VCBO® ADDENDUM 002

project	Intermountain PKH Sports Performance Center Phase 2	project no	20065.01
date	2023-10-31	no. pages	
owner	Intermountain Healthcare		
contractor			
bid date	2023-11-02	bid time	4:00 pm

Electrical Addendum #2 Phase Two

A1 FIRST FLOOR - AREA 1 - DEMOLITION LIGHTING PLAN (PHASE 2)
SCALE: 1/8" = 1'-0"

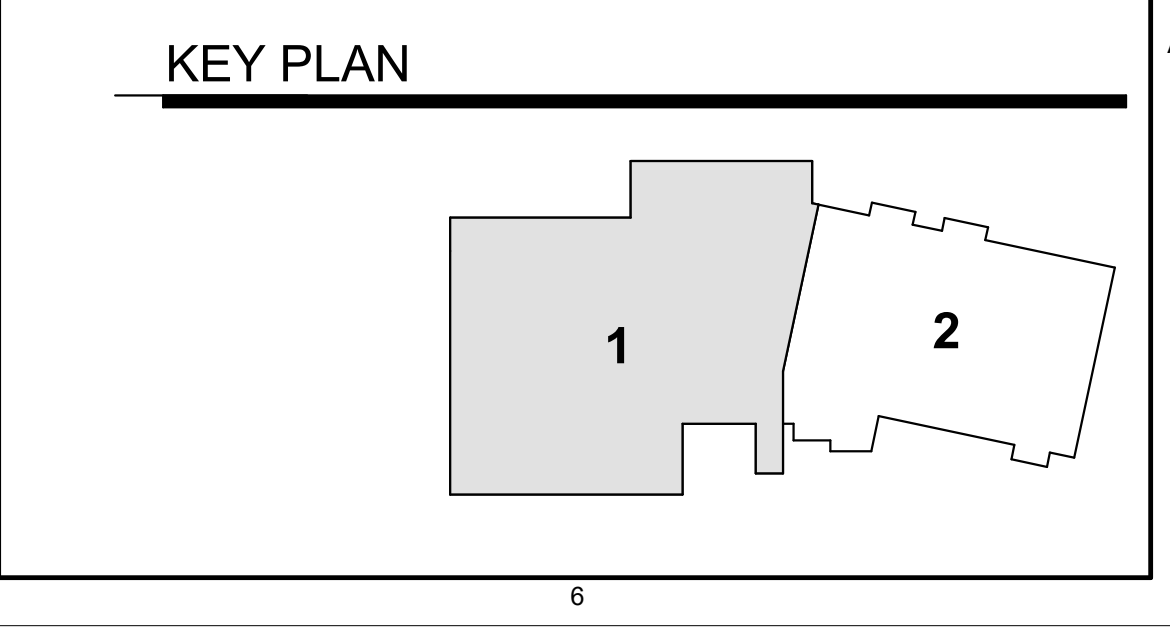
1. EDL101-2 & EDP101-2 – Electrical demolition
 - a. Revised quantity of devices being demolished in existing PT
 - b. Ceiling tile and lighting in existing PT to remain
2. EP101-2 – 1st Floor Area 1 Power Plan Phase 2
 - a. Removed new receptacles in PT Gym 1254
 - b. Deleted enlarged coffee bar 1720A detail B6
 - c. Raceway for X-Ray was installed in phase one.
3. EL101-2 – 1ST Floor Area 1 Power Plan Phase 2
 - a. Removed one NF-4 fixture
 - b. One can light changed from being relocated to existing to remain.
4. EL601-2 – Interior Fixture Schedule

INTERIOR LIGHTING FIXTURE SCHEDULE

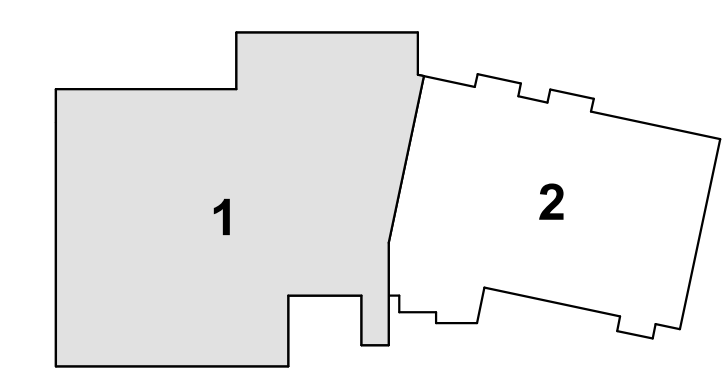
- a. All light fixtures to be Owner Furnished Contractor installed.
5. EY101-2 – 1ST Floor Area 1 Security Plan Phase 2
 - a. Deleted card readers at two door.
 6. FA101-2 – 1ST Floor Area 1 Fire Alarm Plan Phase 2
 - a. Fire alarm system changes are by owner. Contractor to coordinate all fire alarm work directly with owner.
